# PACIFIC GAS AND ELECTRIC COMPANY

November 19, 1971

Re: Docket No. 50-133  
Humboldt Bay Power Plant

DOMESTIC FIRE & RAW WATER SYSTEMS

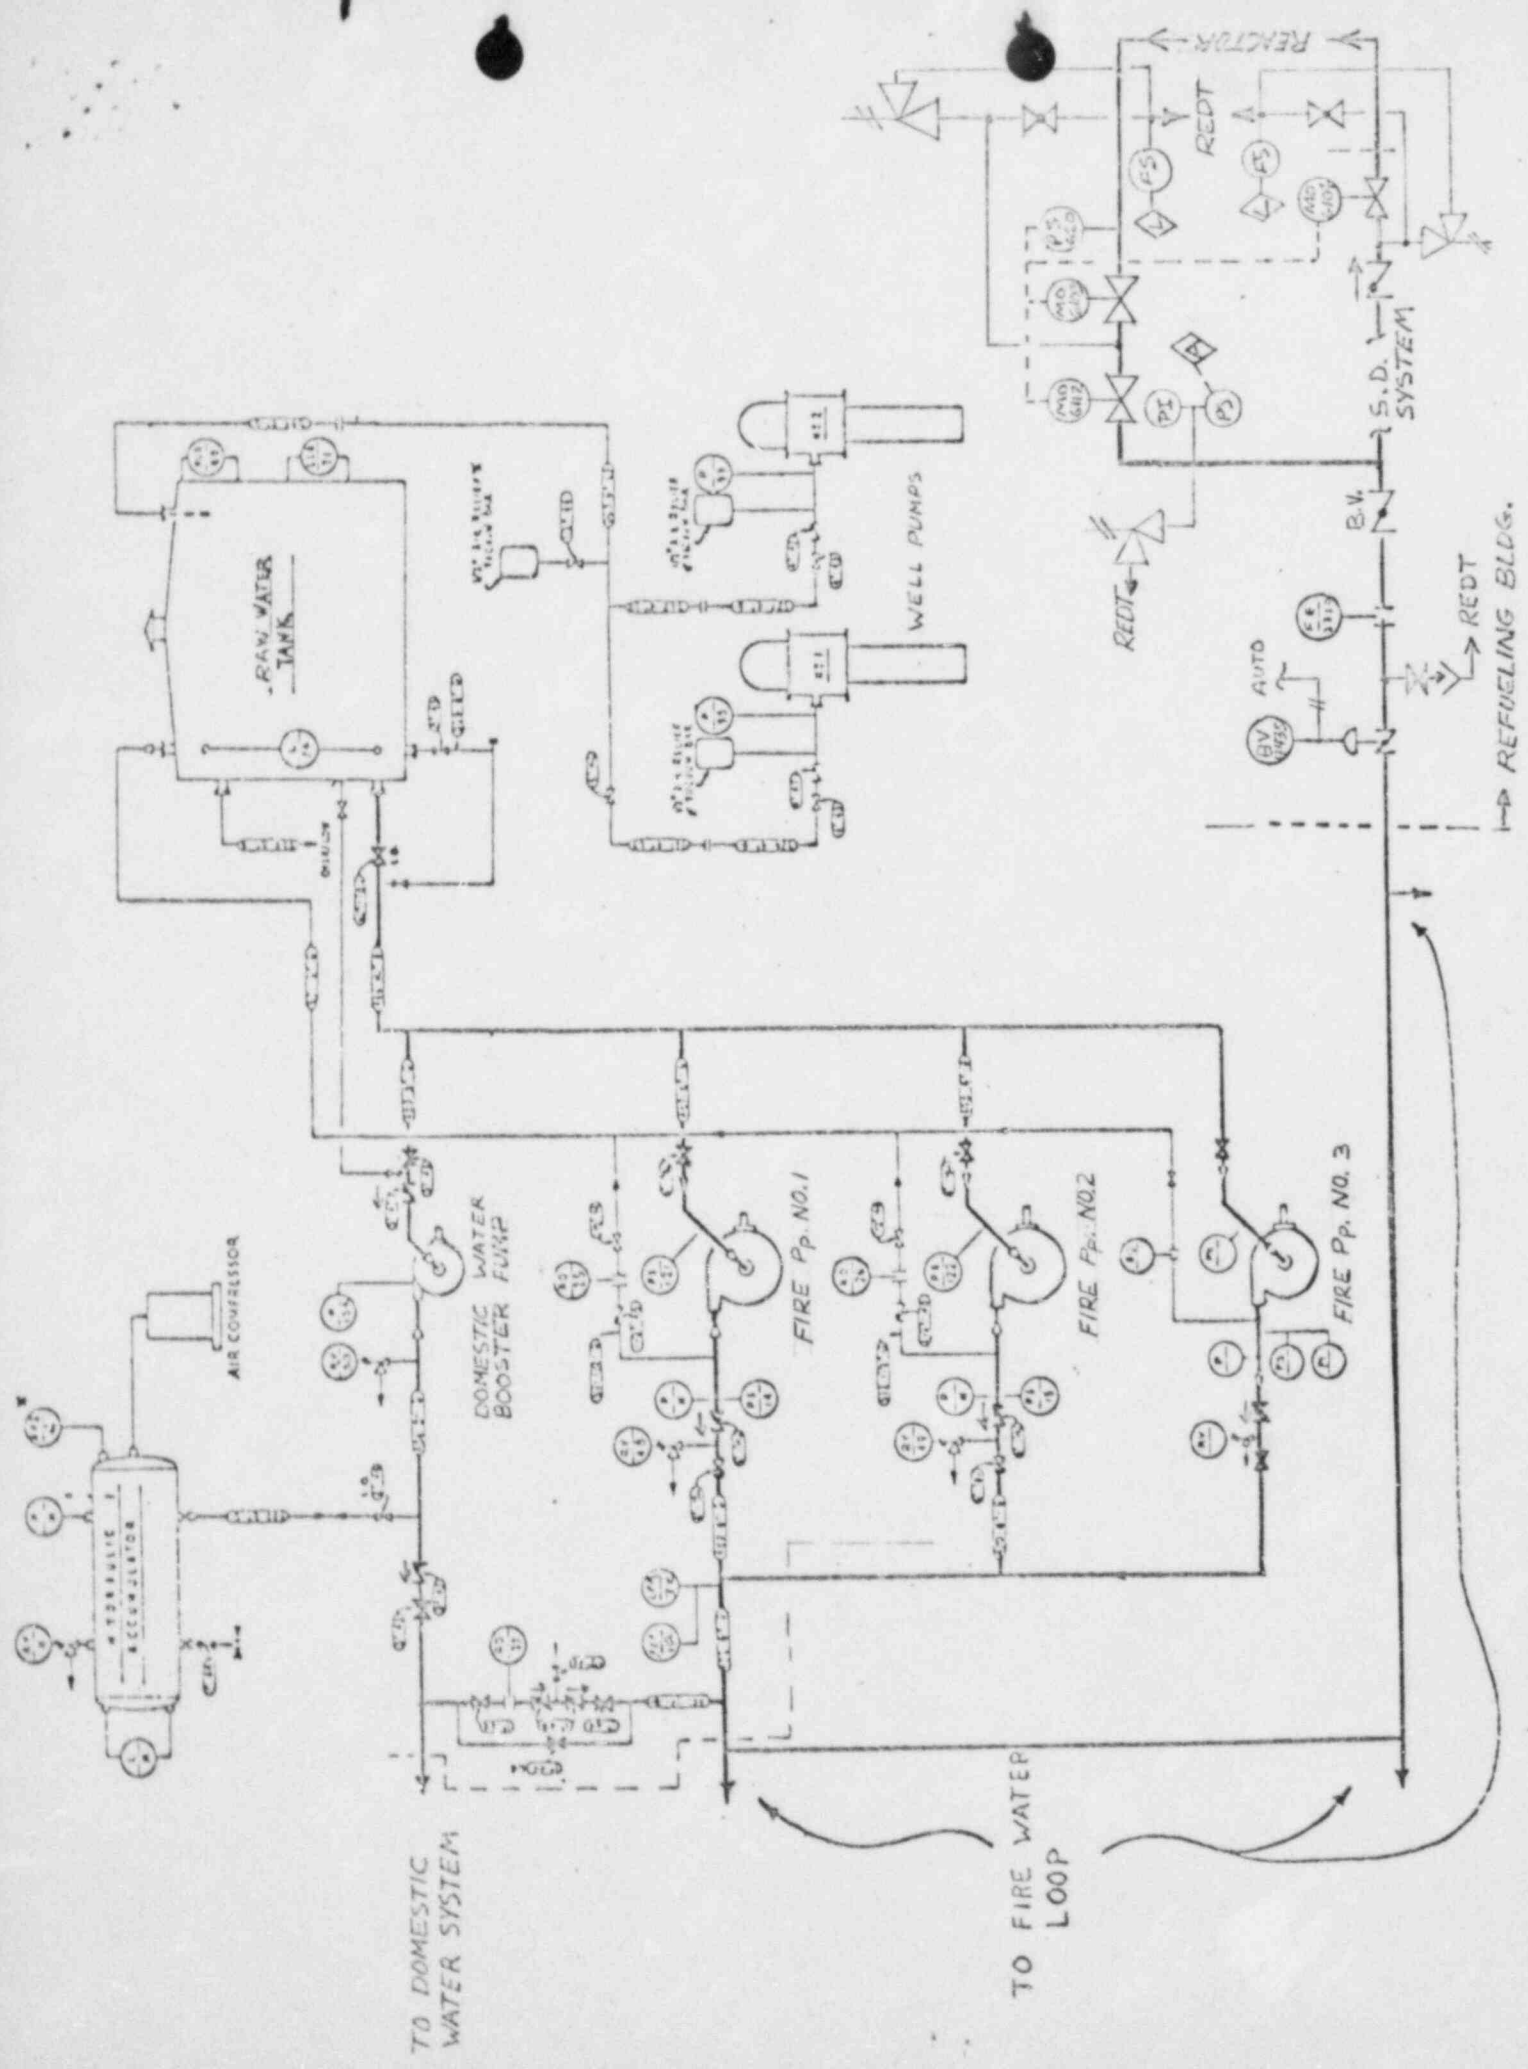
With regard to Item a. included in your letter we do not believe that there is any realistic potential for contamination of the Plant's domestic water system with reactor water via the fire protection system. In addition to multiple mechanical and hydraulic barriers which protect against such contamination a routine program of quarterly sampling and analysis of domestic water for radioactivity has been in effect for many years. There has never been any indication of contamination in the domestic water system. The results of this sampling program were discussed with your inspection personnel in considerable detail during their investigation.

The fire protection system is a source of water for one of the emergency core cooling systems, i.e., the low pressure core flooding system. This system was added to existing emergency core cooling systems in 1965. As shown in the attached figure the domestic water and fire protection system are maintained at 50 to 70 psig by means of the booster pump and hydraulic accumulator. The fire pumps normally are not in service but start automatically if pressure in the fire protection system drops below 48 psig as would be the case if the booster pump malfunctioned. The shutoff head of the fire pumps is approximately 155 psig. Since the fire loop is normally pressurized from the domestic water system any flow through the connecting double check valve crosstie between these systems is from the domestic water system. The fire pumps are routinely tested on a biweekly basis as part of the operational test program for the Unit. Leakage through the crosstie check valves would be readily detected during such tests.

During normal operating conditions with the reactor at pressure the shutdown system up to the normally closed butterfly valve (BV-4435) is at atmospheric pressure and filled with treated distilled water. It would require leakage through a series of at least three valves (as an example M06103, M06112, and BV4435) and pressurization of the shutdown system to allow reactor water to

When the reactor is shut down there are again multiple valve barriers to prevent reactor water from reaching the fire protection system. It would require the simultaneous leakage of butterfly valve BV4435 and the manual valve downstream of the butterfly valve to provide such a path. In addition the pressure in the shutdown system is substantially less than that in the fire protection system under normal shutdown conditions with the reactor vessel head removed. Additional assurance that flow does not occur from the shutdown system to the fire protection water system is provided by a drain valve (telltale) between BV4435 and the manual valve. When the reactor is shut down the manual valve can be closed as soon as the reactor pressure is less than 150 psig. The telltale valve between the butterfly and manual valve can then be opened to provide positive assurance against leakage. The shutdown system isolation valves cannot be opened until reactor pressure is less than 120 psig. (This interlock system is described in IV.A.2. of the Technical Specifications.)

In our opinion, the physical barriers described above, supplemented by the routine sampling of domestic water, provide adequate assurance against contamination of the Plant's fire protection and domestic water systems under all normal operating conditions. Actuation of the low pressure core flooding system in response to a loss of coolant accident signal in conjunction with reactor pressure of 150 psig or less does result in automatic opening of the valves connecting the fire protection system to the reactor (BV4435, MOV6112, and MOV6103). This same signal starts all three fire pumps. During the two second period while the fire pumps are coming up to speed the pressure downstream of valve BV4435 is greater than the upstream pressure. The average

reverse differential during this time interval is 50 psi. The crosstie between the fire system and the domestic water system consists of a 1-inch line containing a flow restricting orifice and two check valves. In our opinion it is completely unrealistic to assume that the contained volume of solid water between the shutdown system and domestic water system (approximately 460 gallons) could be displaced by reactor water since this would require a check valve leakage rate greater than 13,000 gpm. If one assumes any reasonable check valve leakage rate the small amount of backflow which could occur through valve BV4435 would be flushed back into the shutdown system as soon as the fire pumps develop full pressure and the pressure upstream of valve BV4435 exceeds the pressure downstream. Therefore, while the potential exists for temporary contamination of a small section of the fire protection system for a few seconds during operation of the low pressure core flooding system, it is not possible for this contamination to reach the domestic water system. The only actual operation of the low pressure core flooding system in the history of the Plant occurred on July 17, 1970, as a result of a spurious actuation of the system. As a means of further verification, operating procedures have been established requiring that domestic water samples be taken after any activation of the low pressure core flooding system. It is expected that these procedures will be completed and ready for use by December 15.

To provide added assurance that no leakage can occur between the shutdown system and the fire protection system when the reactor is shut down operating procedures for reactor shutdown will be modified to require that the butterfly valve BV4435 be deactivated in the closed position, the manual valve closed, and the telltale valve opened before the shutdown system is activated. It is expected that these modifications to operating procedures will be completed and ready for use by December 15.
